Construction of partition Walls ~~to the~~ and out-houses to the disused mosque at Santeberemur, Chennagiri Taluq.

Subject Construction of partition walls and out houses to the disused Mosque at Santebennur, Chennagiri Taluk with a view to convert it into a Musafir Khana.

Submitting for orders of Govt in Jenl dept, an Estimate Amtg to Rs 2,647 for Constg. partition walls & out-houses to the disused Mosque at Sankebennur in Channagiri Taluk. —

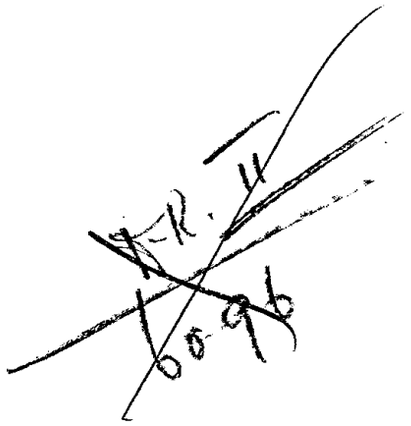
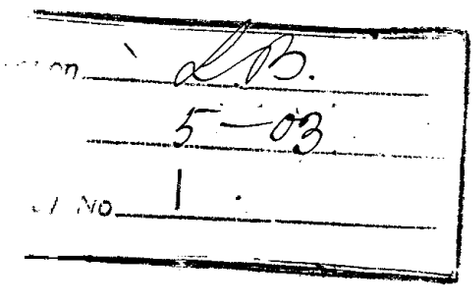
has prepared an estimate for Rs 2,647 for walling up three arches on either side of the building and to attach Caste and European Kitchens, and stables to it for the use of the travelling public (Vide plan).

"It (to convert the building into a ~~Mosque~~ Musafirkhana by walling up the arches) is a doubtful economy. It will destroy the present structure and will not make a comfortable Musafirkhana."

3. The Mosque was of brick and head, used on one occasion by Sir Mark Cubbon to hall in when on tour, and its situation between the Sasalu Naranay Station and Anekere is no doubt very convenient for the purpose. But, as the Executive remark it will not make a comfortable Dak Bungalow and the alteration necessary to convert it into one will destroy the interest of the ancient building being a measure of doubtful economy.

4. The Mosque itself is too substantial to suffer if left as it is, but the pavilions at the Honda will not last unless something is done

Copies of the Chief Engineer's letter read above & of its enclosure will be forwarded to the Dy. Commissioner, Shimoga & he will be requested that he will see to the preservation of the building and the Honda referred to in the letter read above the cost of any repairs required thereto being defrayed from the P. W. Budget.
